Panel Report

**Greater Geelong Planning Scheme Amendment C367 and
Permit Application PP1463/2016**

2-120 Mollers Lane and 10 Willows Place, Leopold

22 January 2019

Figure 3 Exhibited Overall Development Plan

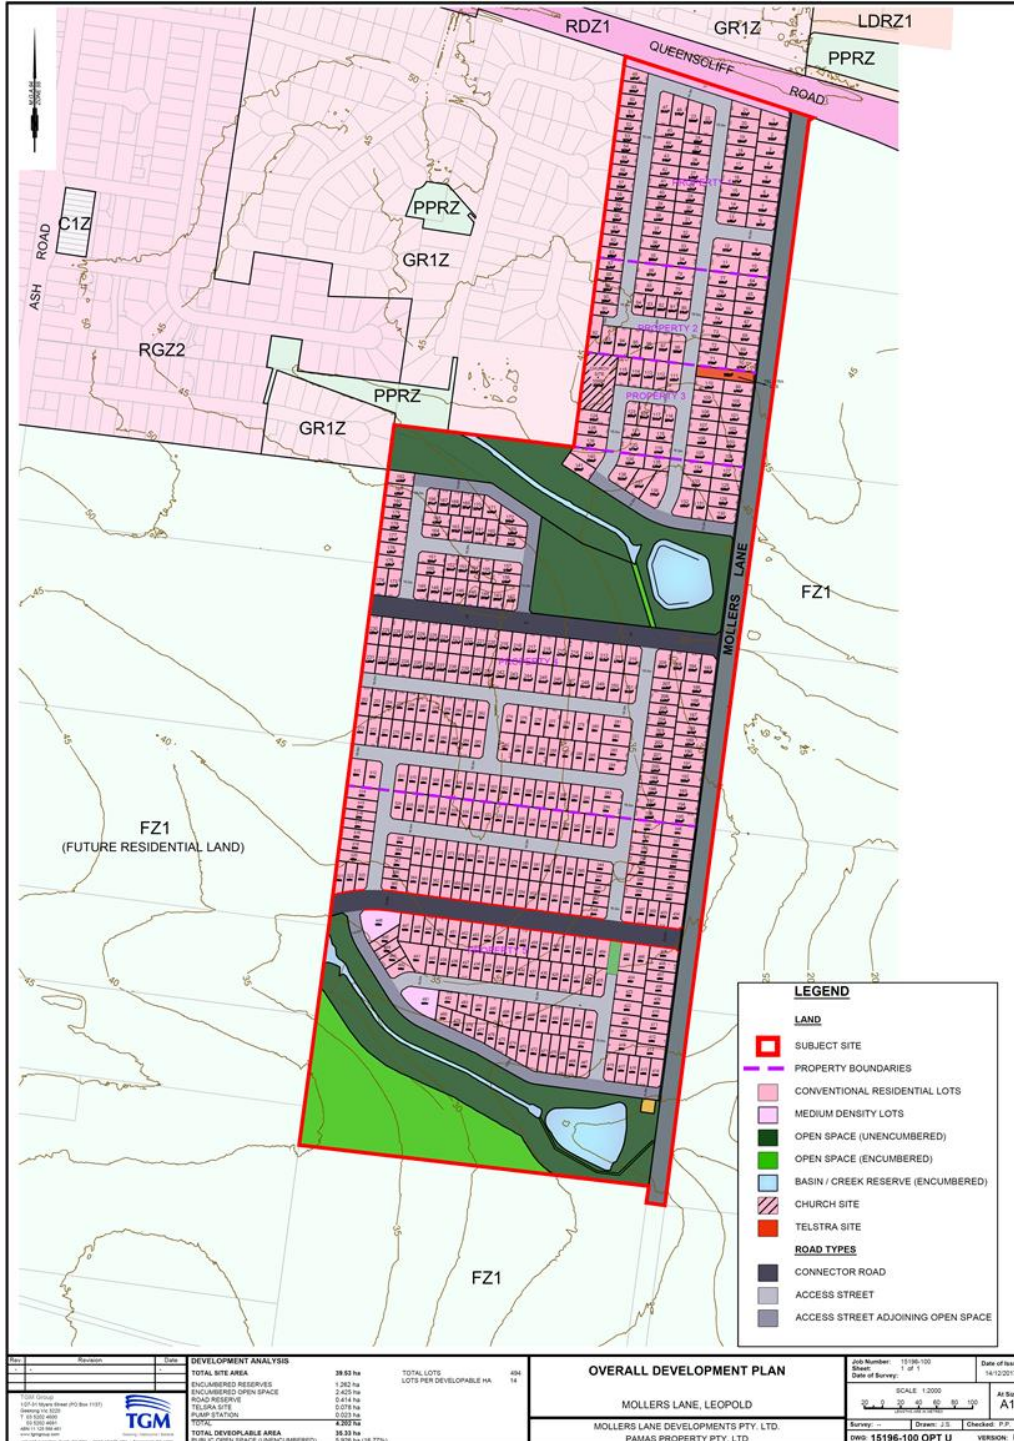
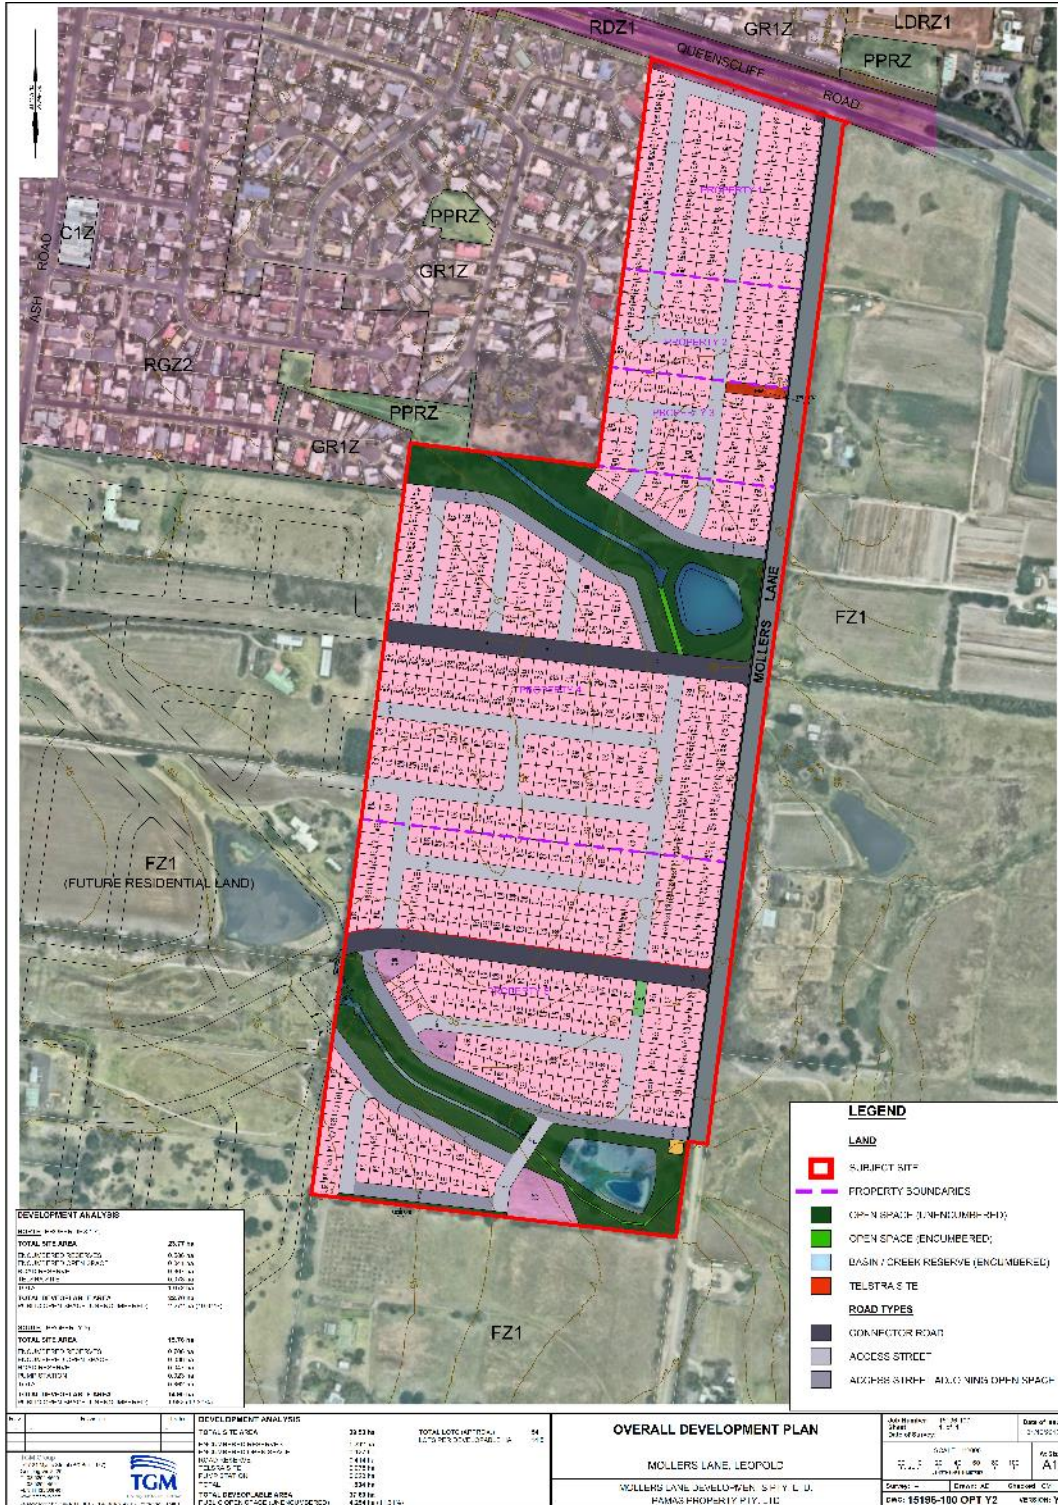
On 16 November 2018 the Proponent circulated a revised Overall Development Plan Version Y2 (the amended ODP). The Proponent explained the key changes as:

- the number of lots proposed has increased from 493 to 541
- the net developable area has increased from 35.33 hectares to 37.6 hectares
- the development density has increased from 13.98 lots per developable hectare to 14.5 lots per developable hectare.

The changes represented in the amended ODP do not, in the Panel's view, represent a transformation of the proposal shown in the exhibited ODP. Rather, they represent a modification of the exhibited ODP. On that basis, the Panel agrees with the Proponent that the changes are within the scope of changes that a planning authority could recommend under section 96G.

The amended ODP (extracted as Figure 4) removes the local park and the south-west wedge and replaces them with residential lots.

- 9. Include condition 1(c) in Appendix D requiring the local park adjacent to the northern retarding basin to be retained.**
- 10. Amend condition 1 to refer to Version Y2 of the Outline Development Plan dated 31 October 2018 instead of Version U dated 14 December 2017, so as to allow the residential development of the land to the south of the southern waterway and open space corridor.**

- 18. Inform the Minister for Planning that before a permit is issued, further notice should be given of the amended Outline Development Plan (Version Y2) under section 96H(2) of the Act.**

Figure 7 Typical cross section of topography south of the subject land

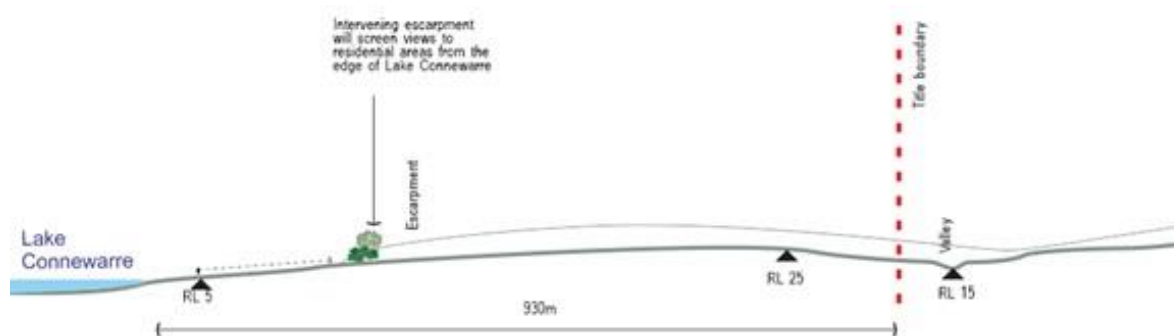
The Proponent called Mr Wyatt to present landscape and visual impact evidence at the Hearing. His evidence included Figure 7 below, which shows a typical cross section of the topography between the Lake and the southern boundary of the subject land. His evidence was that the cross section demonstrates that a residential property on the subject land would be visually screened from the edge of Lake Connewarre by the escarpment face.

Mr Wyatt assessed the visual impacts of the proposed development from various viewpoints, including views from several viewpoints along Barwon Heads Road (to the south of Lake Connewarre) across the lake towards the subject land, which are among the views sought to be protected by the SLO10. His evidence was that, due to a combination of factors including distance, screening from roadside and other vegetation and intervening topography, houses on the subject land would not be visible from these viewpoints, or (where they could be seen) would be “*barely noticeable*”.

Mr Wyatt’s initial assessment was that the SLO10 should be reduced to generally align with the 25 metre land contour, resulting in a small area in the south east corner of the subject land remaining within the SLO10. Council decided to exhibit the Amendment in a form which aligned the SLO10 boundaries with title boundaries, effectively removing the SLO10 from the subject land altogether. Mr Wyatt addressed this in his expert evidence, and concluded that the gentle ridgeline further south of the subject land effectively blocks views to the south east corner, as demonstrated in Figure 7. He was satisfied that the further contraction of the SLO10 proposed by Council would not impact on the landscape values sought to be protected under the SLO10.
